Agenda Item: Fullwood Station Administrative Amendment

DATE: April 5, 2016
FROM: Mary Jo Gollnitz

RE: Fullwood Station – Administrative Amendment

**FULLWOOD STATION
 SINGLE-FAMILY SUBDIVISION**
 PROVIDENT LAND SERVICES, INC. | MATTHEWS, NC | MECKLENBURG COUNTY
OVERALL GRADING PLAN

C-4.0

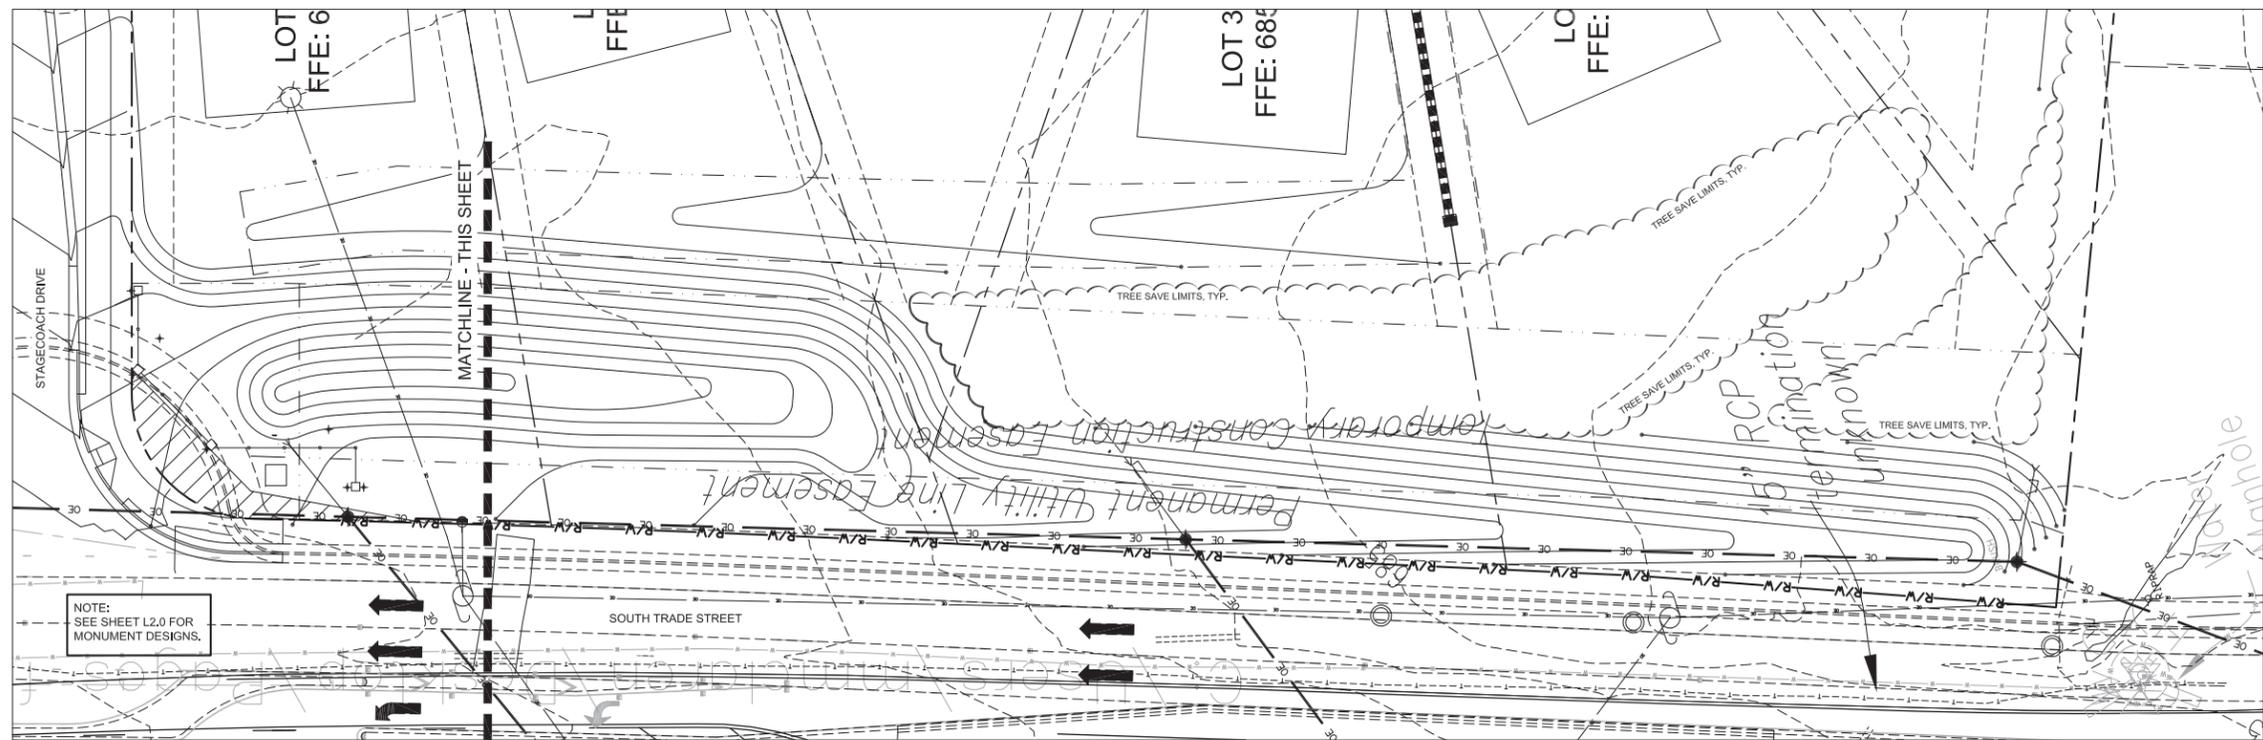
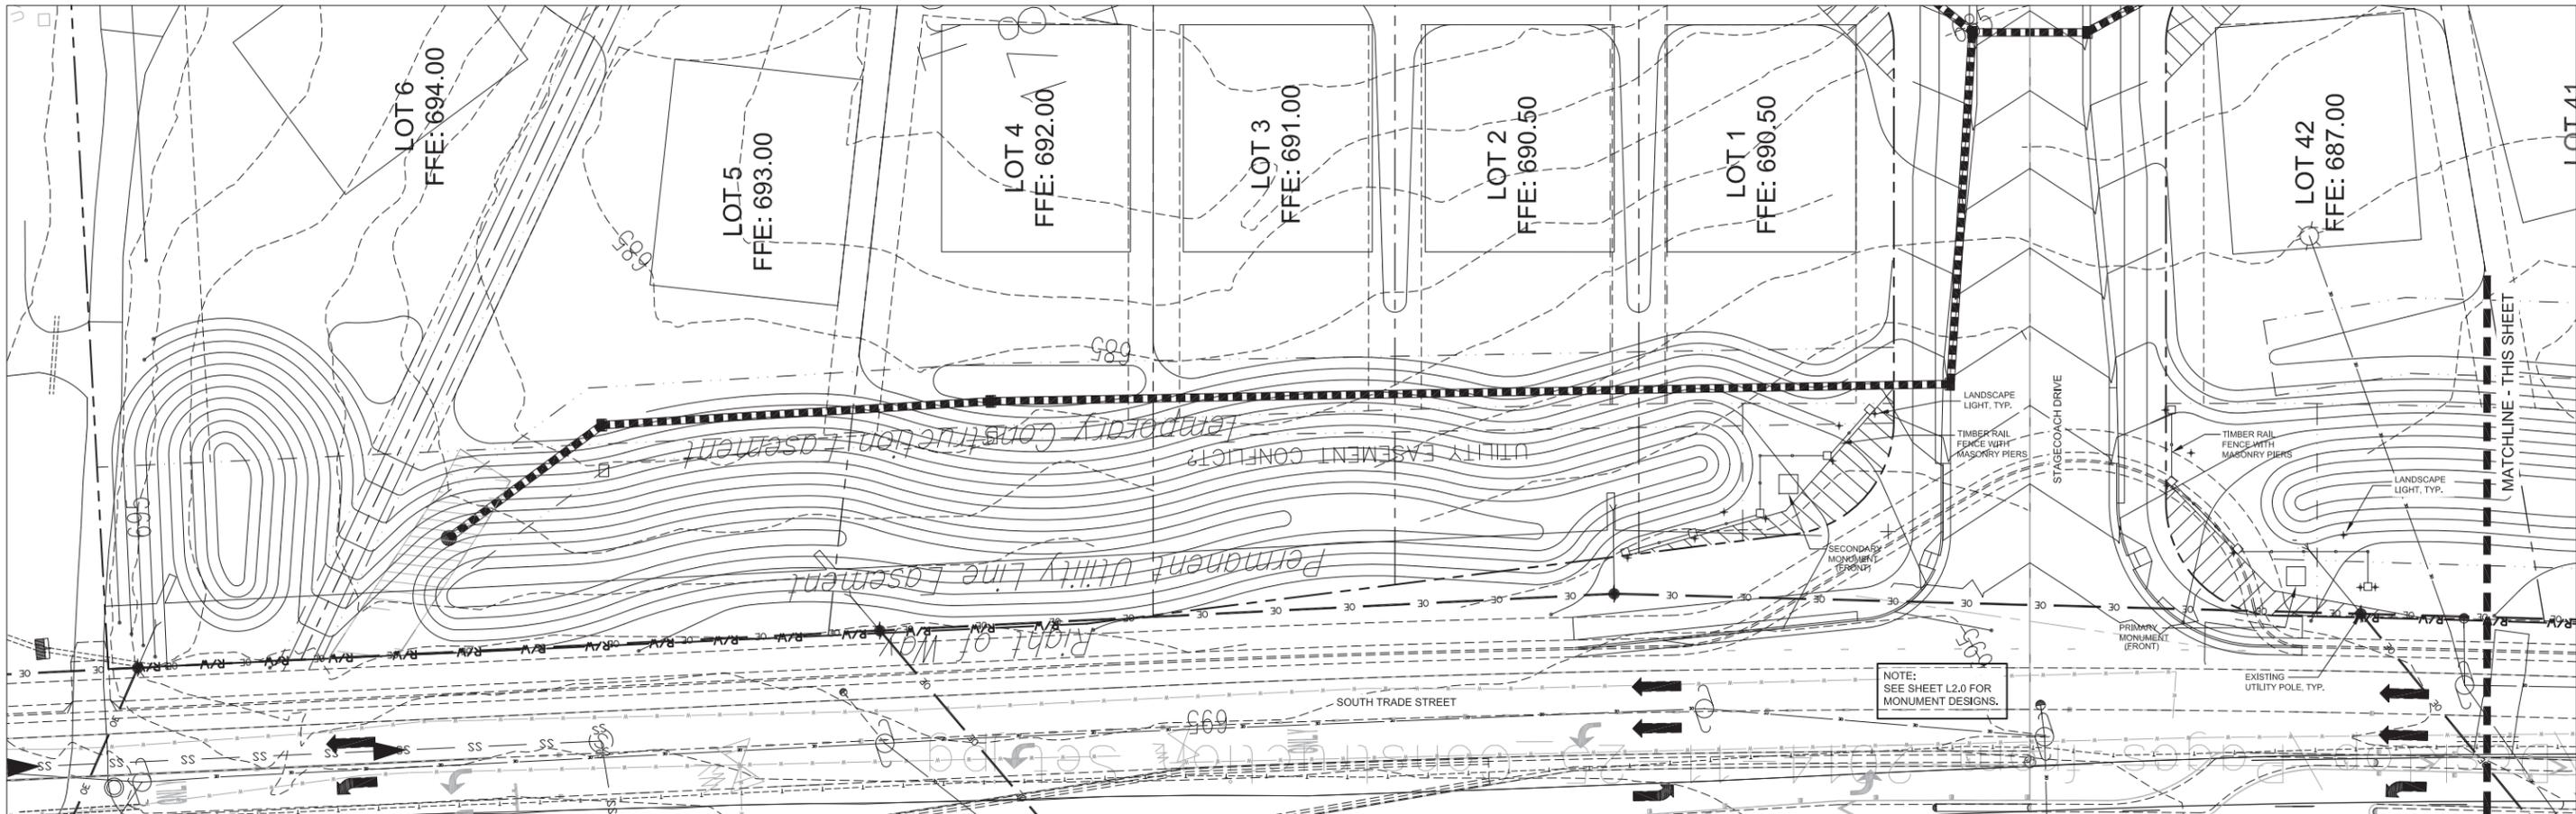
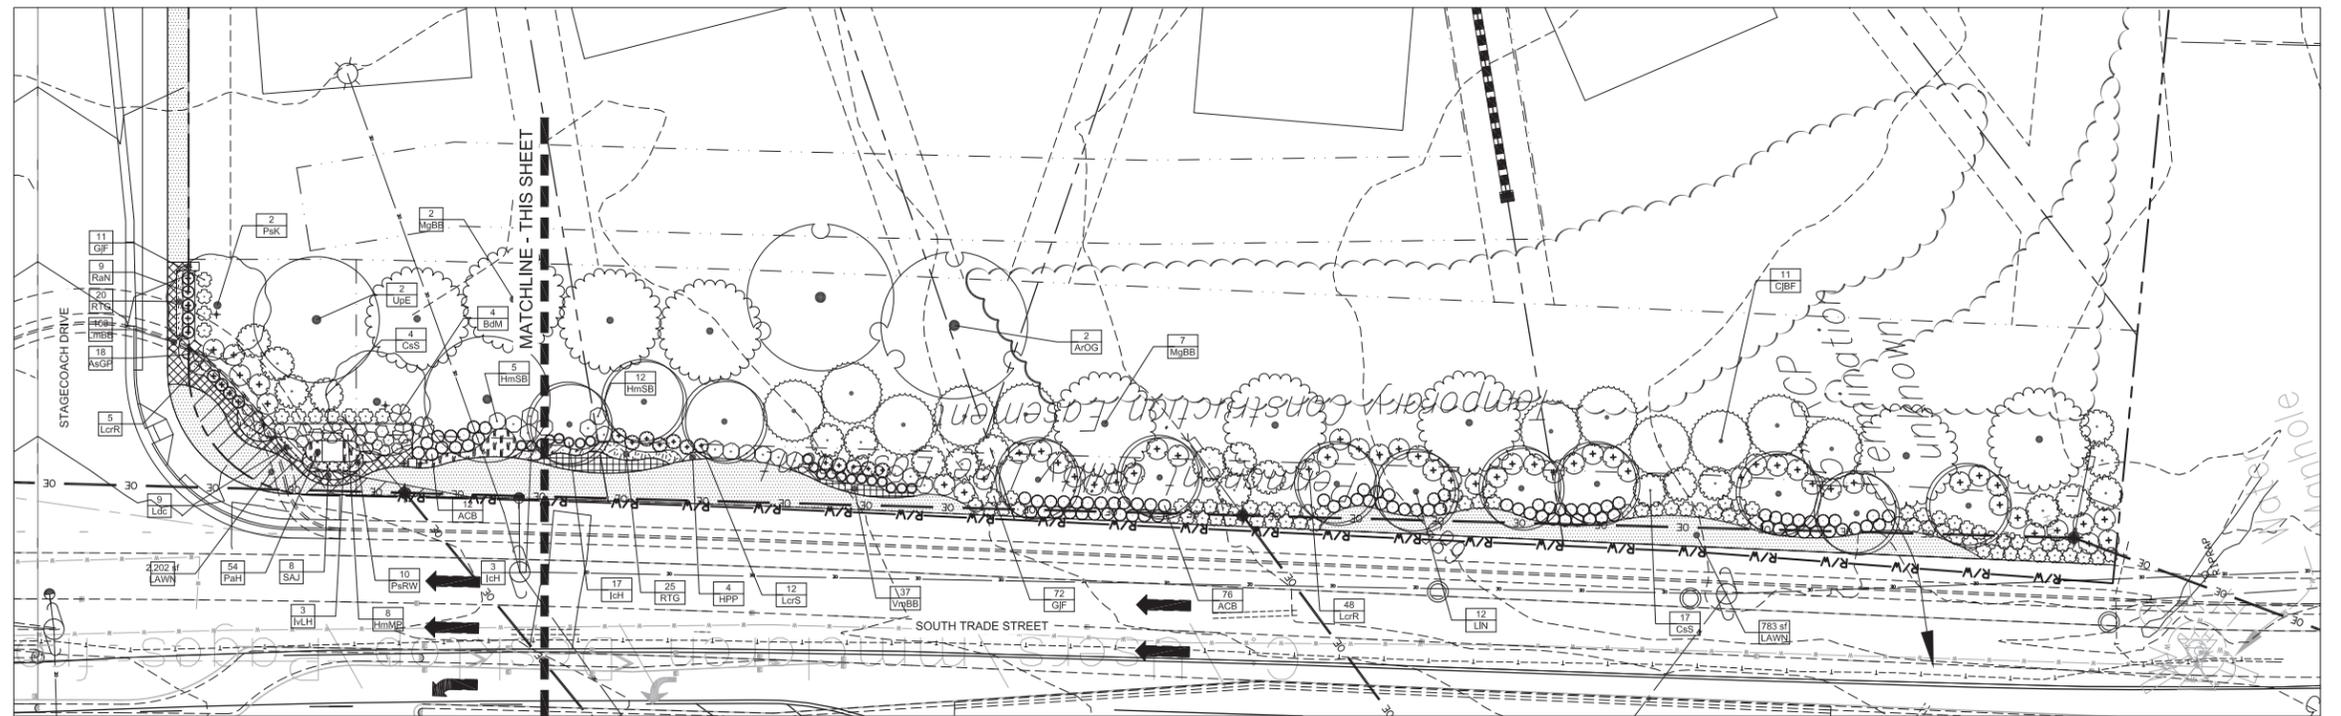
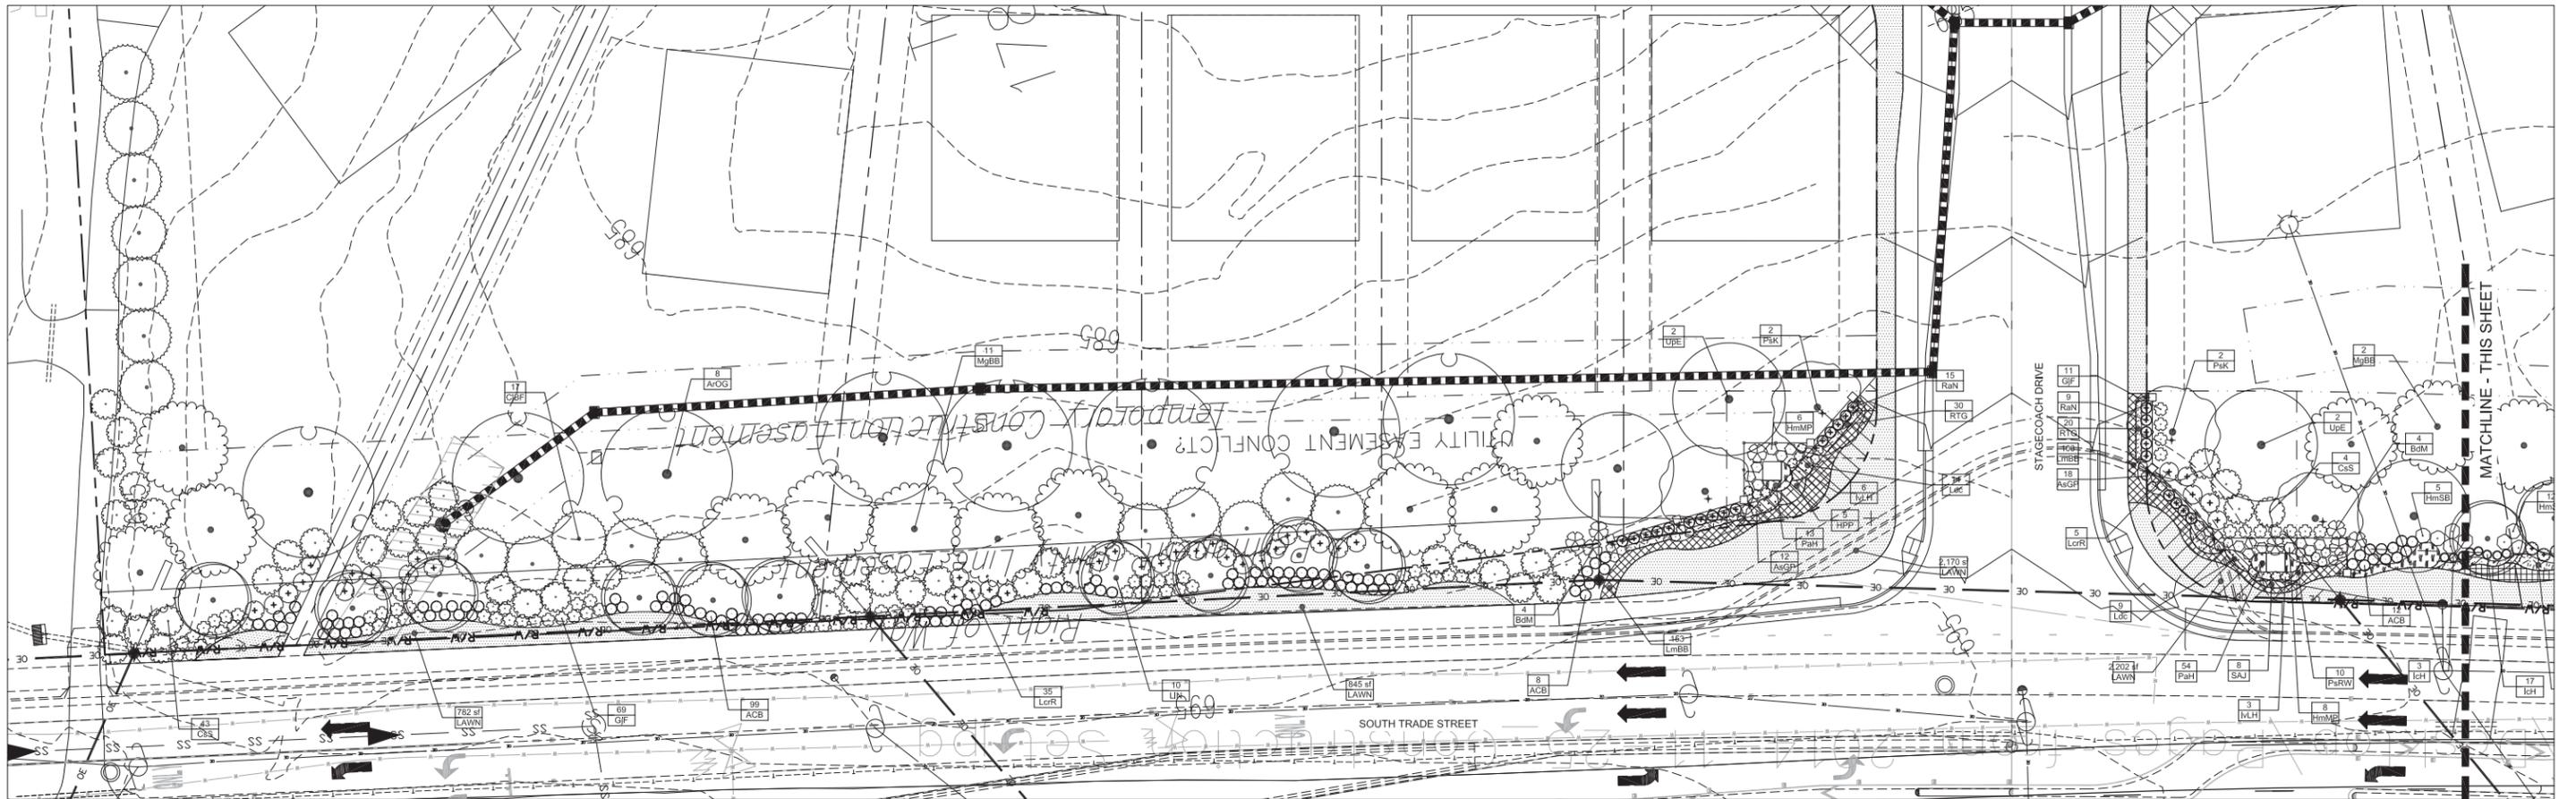
1. Request to move pedestrian access with steps out to S. Trade Street to between Lots 5 & 6. Pedestrian sidewalk will be 6' wide.
2. Request to change location of bridge on internal mulch trail. Exact location of pedestrian bridge will be based on existing topography & natural creek location. Mulch trail will partially follow sewer line.

3. Request to terminate internal trail at the rear of property line, near Mr. & Mrs. Ehlers' property. Developer will provide a fee in lieu towards a future possible 6' wide x 140' long concrete sidewalk connection alongside The Ehlers' property to the Chesney Glen neighborhood. Fee is based on current concrete costs of \$3.50 per square foot x 6' x 140' for a total fee of \$2,940. Future connectivity, construction, and right of way acquisition will be the responsibility of the Town of Matthews.
